MEETING: **BUILDING CONSTRUCTION OVERSIGHT COMMITTEE**

DATE AND TIME: **THURSDAY, APRIL 30, 2020 7:00 p.m.**

Re: Firemen's Park Shelter – Review & Discussion – 30% Project Plans

ITEM TITLE: Dheinsville Pavilion-Color Selection

Sheet Number
A101

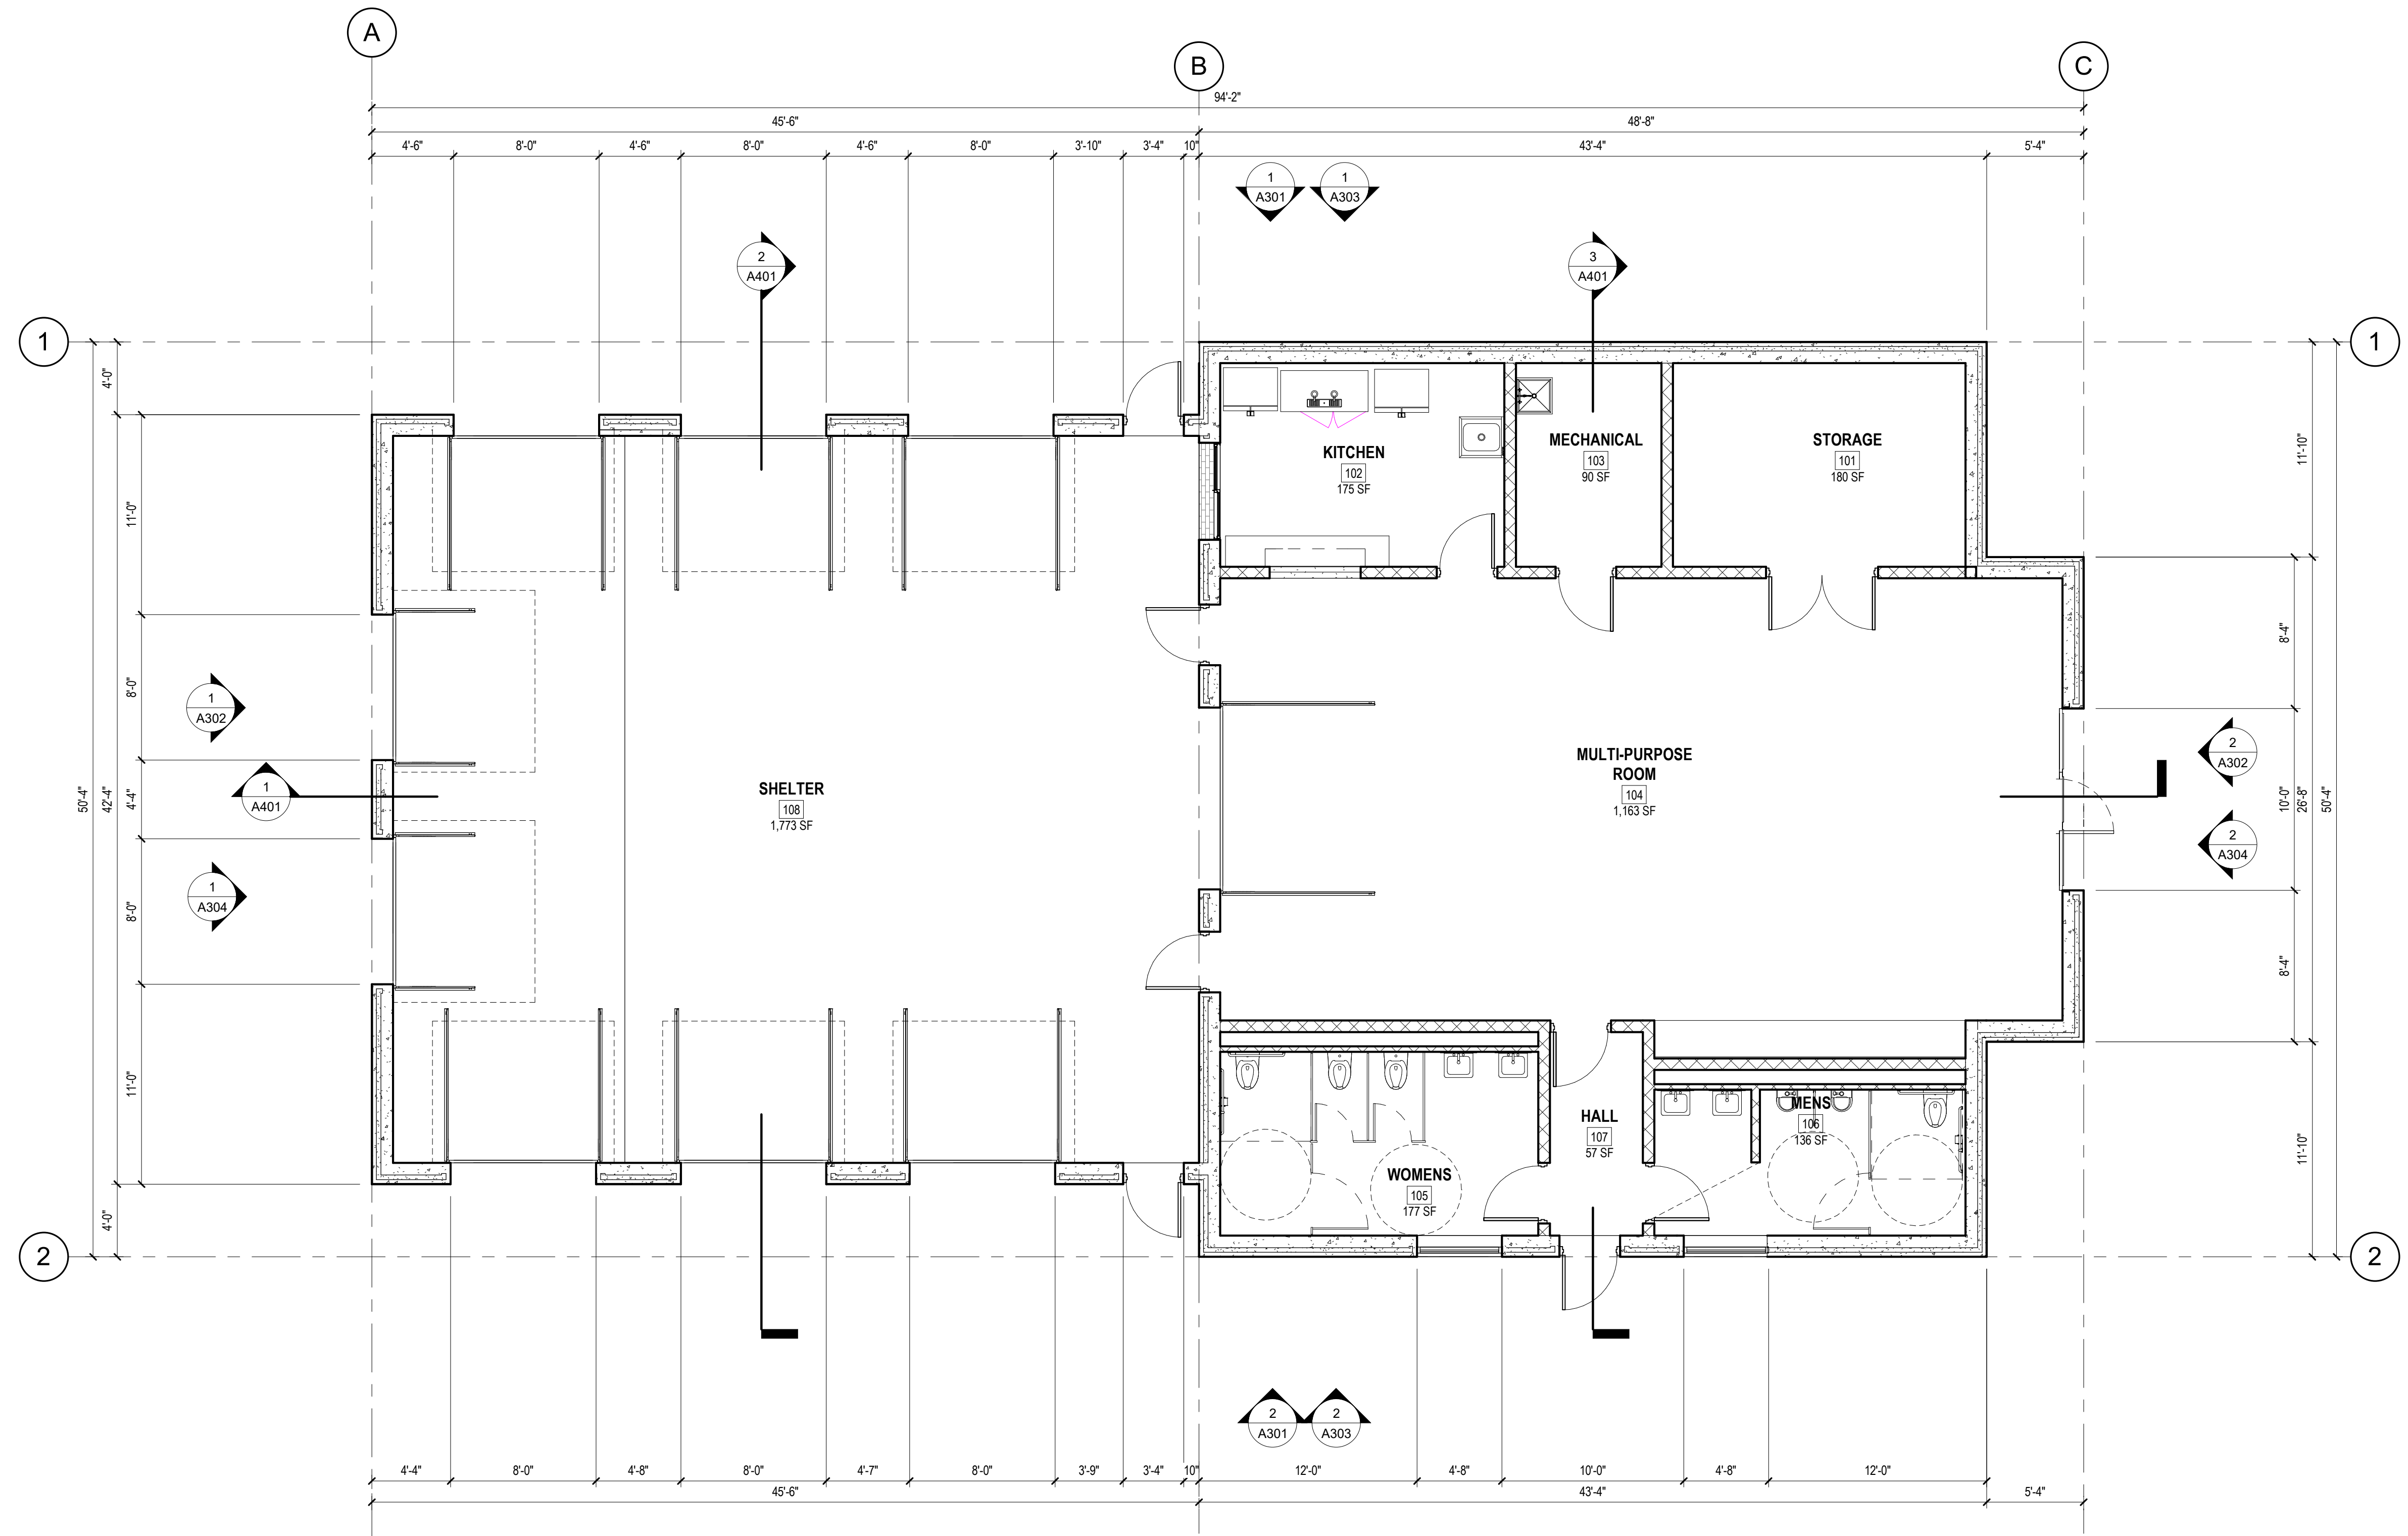
At this time, staff is requesting input/feedback from the Building Construction Oversight Committee. Included in the meeting packet are 30% plans and some renderings for the shelter.

Sheet
EXTERIOR ELEVATIONS

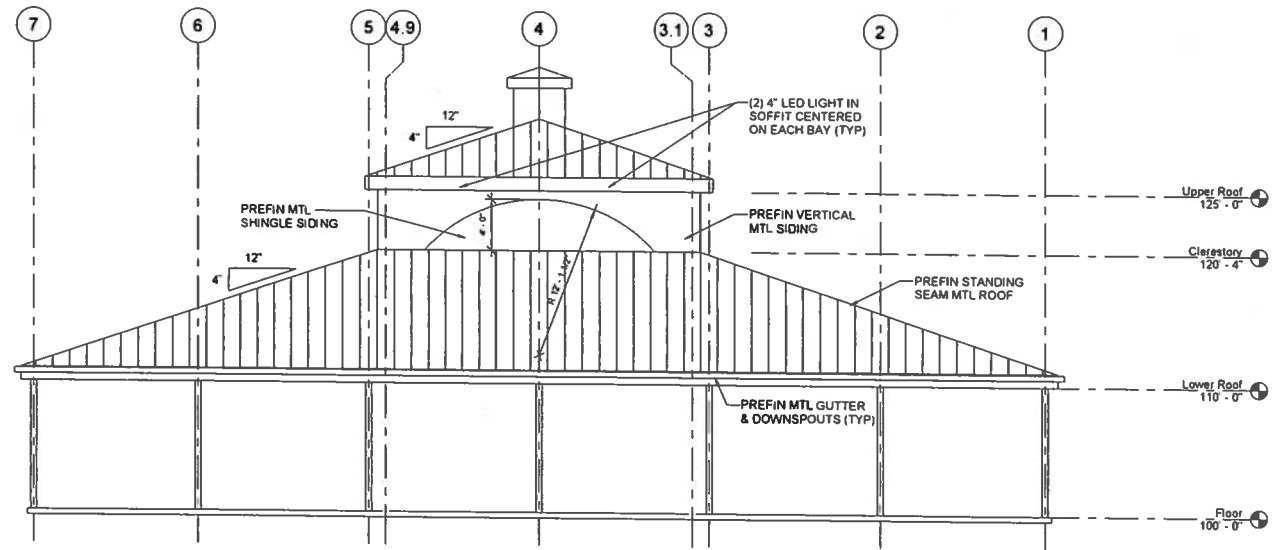
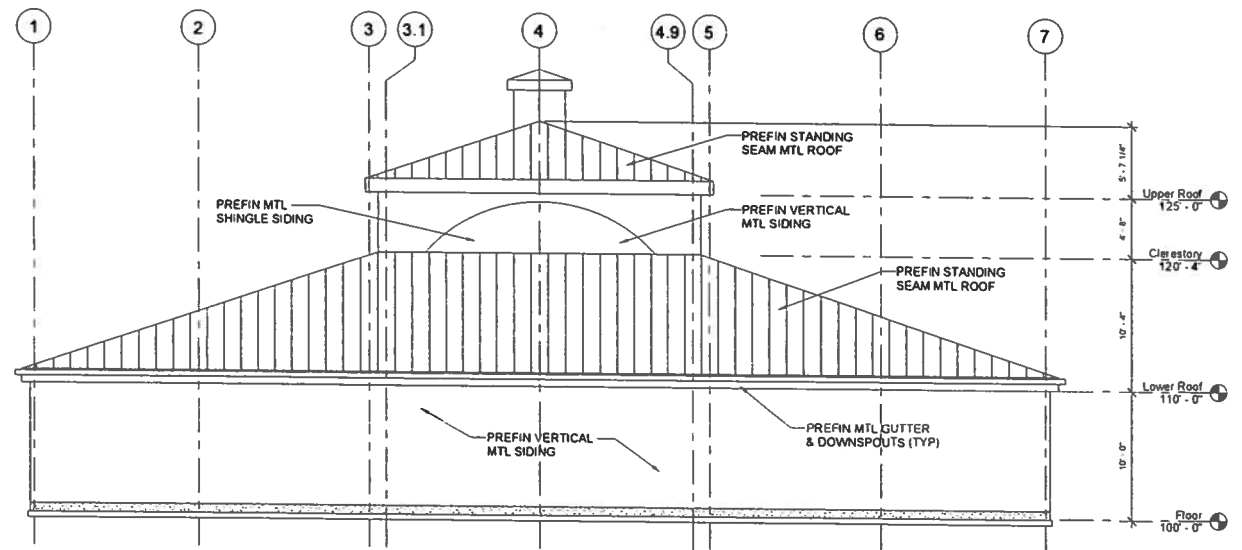
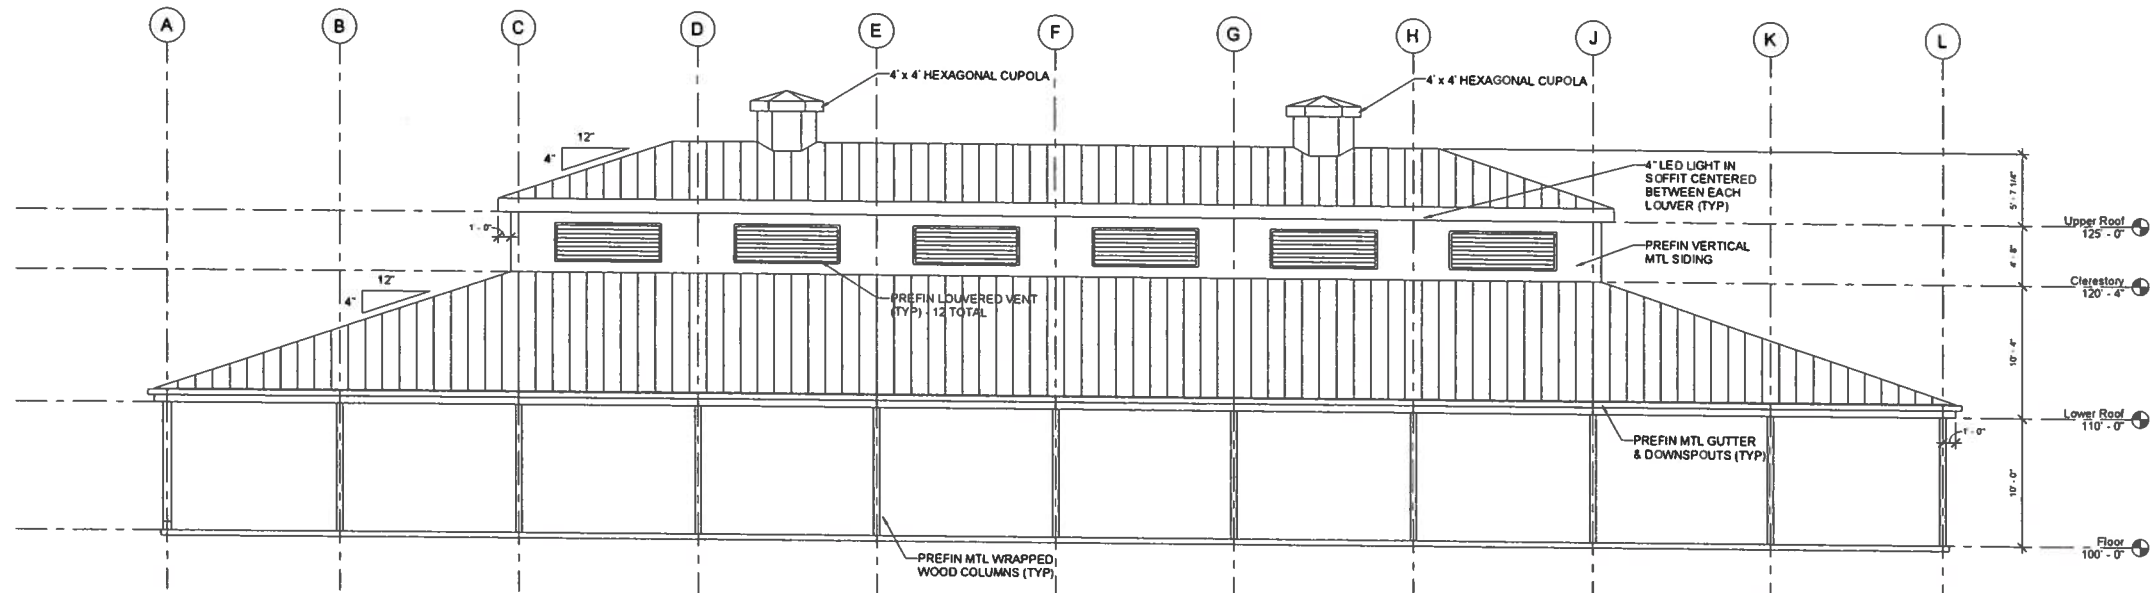
Staff is returning the BCOC as previously directed for the selection of the building colors. Staff has met with the Keller, Inc staff to obtain their experienced opinion only as a start to the selection of a color scheme for the Pavilion. Attached is a presentation of the initial color selection. In addition, staff will have the standard color pallet from Morton Buildings and LP Siding for reference and additional color selection.

- 1) Roof (charcoal-Morton)
- 2) Wall (beige-Morton)
- 3) Trim (off white-Morton)
- 4) LP Siding on raised section (olive)
- 5) Semi Circle at east & west ends of raised section (shake/canyon)
- 6) Louvers (propose to match trim/no color chart at this time)

OPTION 1

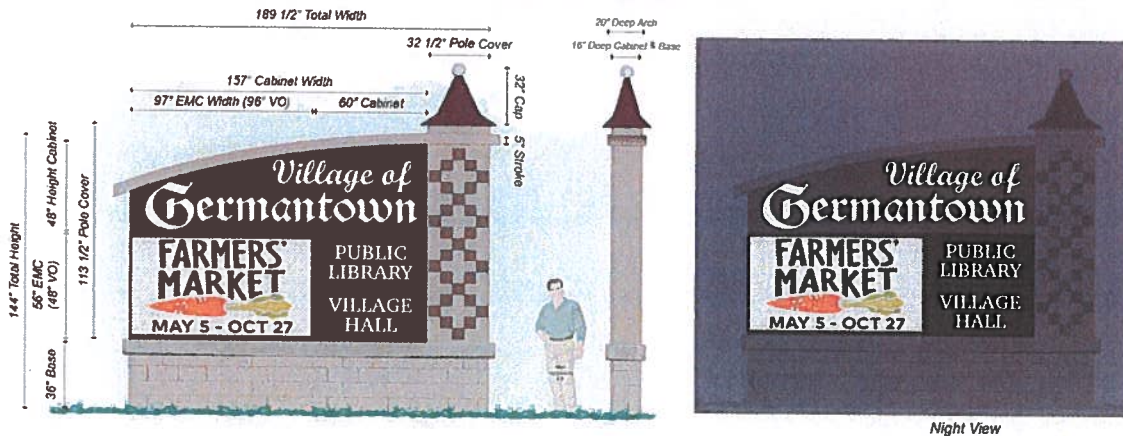
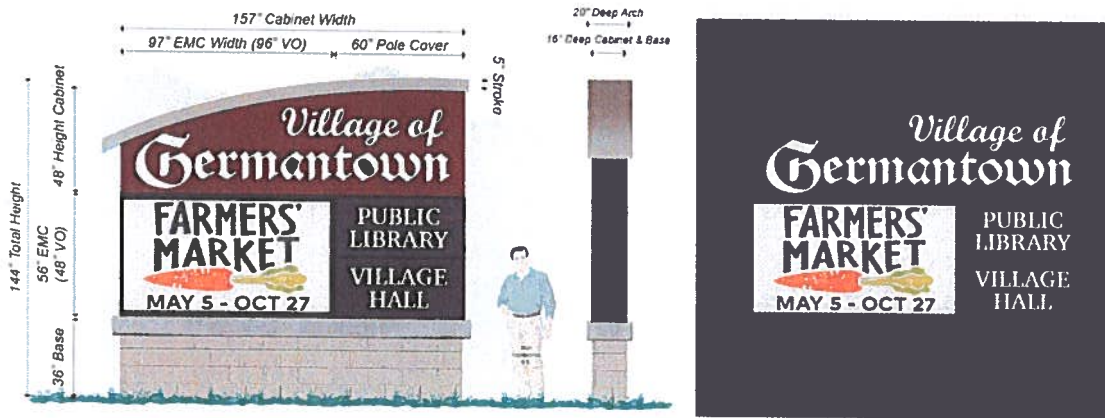
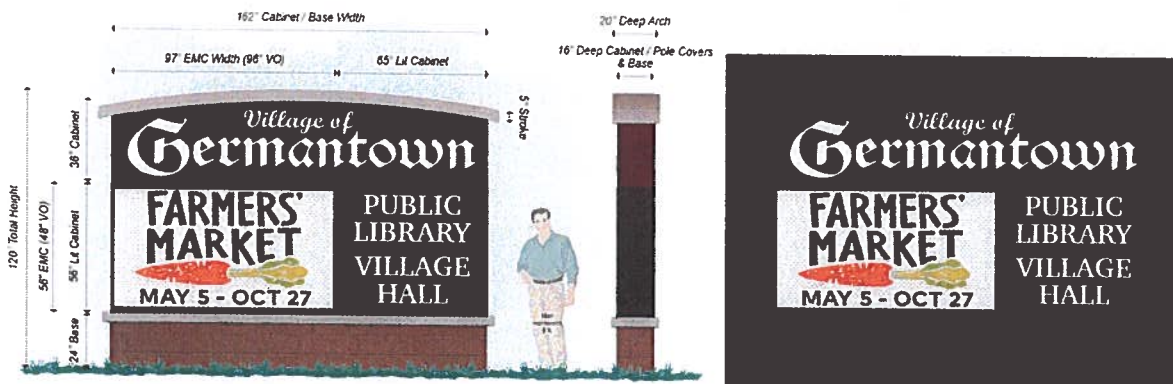
Staff has surveyed the Village employees of Village Hall and the Village Library. The survey included four varying selections of proposed sign styles. Staff took the two signs with the most votes and a new sign submitted by a staff member and surveyed the Board of Trustees (current & outgoing). The signs presented to the trustees is attached. Option #1 received the most votes from the Trustees. The votes where: Option #1 (5); Option #2 (2) & Option #3 (2). One current Trustee and one outgoing Trustee did not reply with a vote.

Staff is requesting the BCOC approve Option #1 and direct staff to send out for bids.

{of the two votes one} voted for #3 but could also agree to #1
